8x930Hx (8x930HD/HE & 8x930HF/HG) SPECIFICATION UPDATE

Release Date: February, 1999

Order Number: 272962-013

Figure 1. RST Source From V_{CC} and V_{BUS}

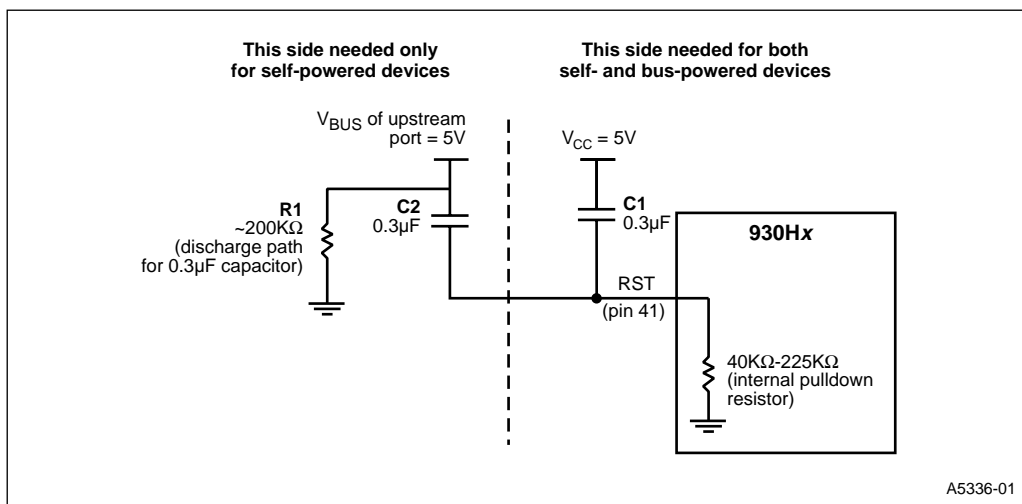
PROBLEM: When a self-powered, suspended hub is reattached to the host, it could be accidentally recognized as a low-speed device. This is caused by the 8x930Hx A-1 driving K signaling upstream and the host incorrectly sampling the speed of the device immediately after connect instead of after USB reset.

WORKAROUND: To fix this problem, you must modify the reset circuitry on current 8x930Hx designs. **Figure 1** depicts two circuits, one for a bus-powered hub and another for a self-powered hub. For bus powered devices, the circuit is the same one that is given in Figure 14-1 on page 14-1 of the *8X930Ax, 8X930Hx Universal Serial Bus Microcontroller User's Manual*, except the capacitor value has been changed from 1.0 μ F to 0.3 μ F.

For self-powered devices there are two requirements:

- The reset circuit design needs to be activated when the board is first powered-on.
- If the board is already powered-on, then a connection to the host should initiate reset. By connecting another capacitor to V_{BUS} (C2, as shown in **Figure 1**), a reset pulse is sent to the chip by either a power-up or by a USB connect.

The circuit shown in **Figure 1** uses the following components:

- C1 — Used in conjunction with the internal pulldown resistor to generate a 20 ms pulse of reset. For bus-powered devices, $V_{CC} = V_{BUS}$. This creates a 20 ms pulse upon connection to the host. For self-powered devices, a 20-ms pulse will occur regardless of the state of V_{BUS} if the capacitor ratios remain 1:1. The circuit operation and timing relationships rely on $C1 = C2$.
- C2 — Used only for self-powered devices. The capacitor delivers a 20-ms pulse to the RST pin when the V_{BUS} signal is detected upon device connection.
- R1 — Provides a discharge path for C2. This resistor is mandatory. If R1 is not present, C2 will not discharge the reset pulse and therefore will not allow a proper chip reset during device connection.

Figure 5. External Code Fetch, Nonpage Mode

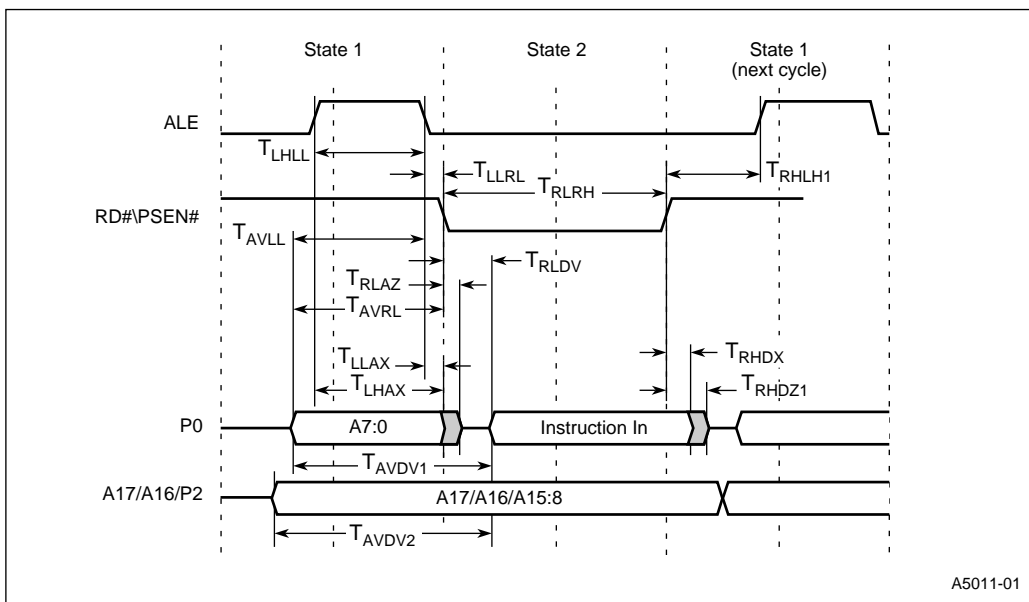
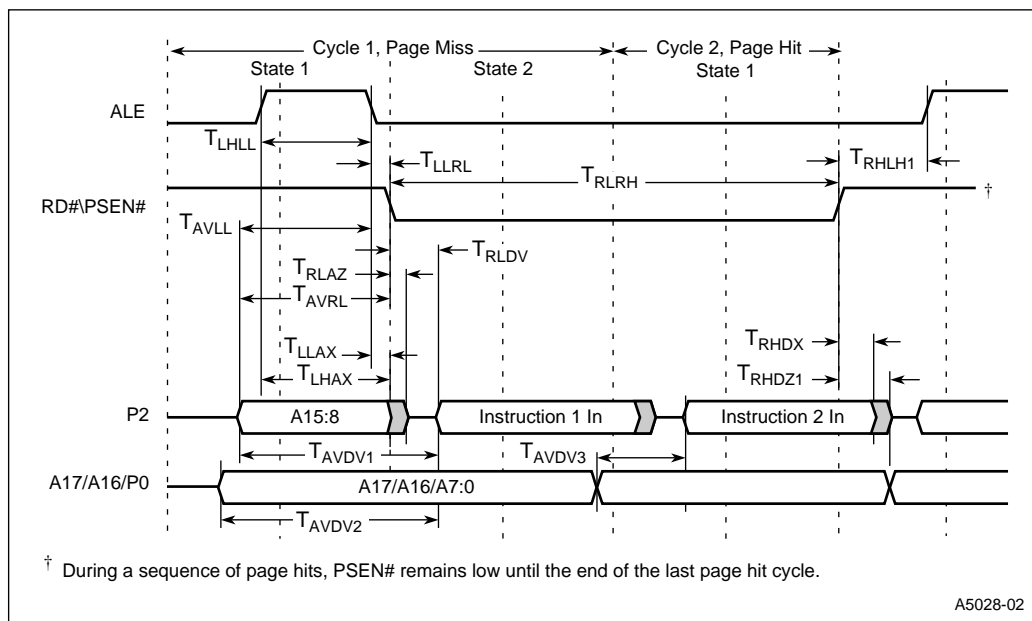
PROBLEM: The T_{RHDZ1} (Instruction Float After RD#/PSEN# High) specification on the 8x930Hx when operating at 12 MHz is 10 ns. However, a slow memory device such as an EPROM typically takes approximately 30 – 90 ns to float its output. (This specification, generically called $TPHZ$, may vary depending on the memory type and manufacturer.) Figures 5 and 6 illustrate the T_{RHDZ1} timing.

The difference between the T_{RHDZ1} and $TPHZ$ specifications causes contention on the data bus (P0 in nonpage page, P2 in page mode). The 8X930Hx begins to drive the address for the next bus cycle while the memory device is still driving data from the previous bus cycle.

To prevent this contention, designers can use a buffer to isolate the output of the memory device from the data bus (port 0 or port 2) of the 8x930Hx. This will prevent the memory device from driving the data bus during the critical period after T_{RHDZ1} expires. We suggest a buffer such as the 74F541 octal, three-state line driver shown in [Figure 7](#).

Figure 5 illustrates the connections of an 8x930Hx configured for nonpage mode with EPROM and RAM in external memory. If your system uses a different configuration, your circuit will be different from the example. The 74F541 is enabled to pass data from the EPROM to the 8x930Hx (port 0) when OE1# and OE2# are active. Table 3 is a truth table for the 74F541.
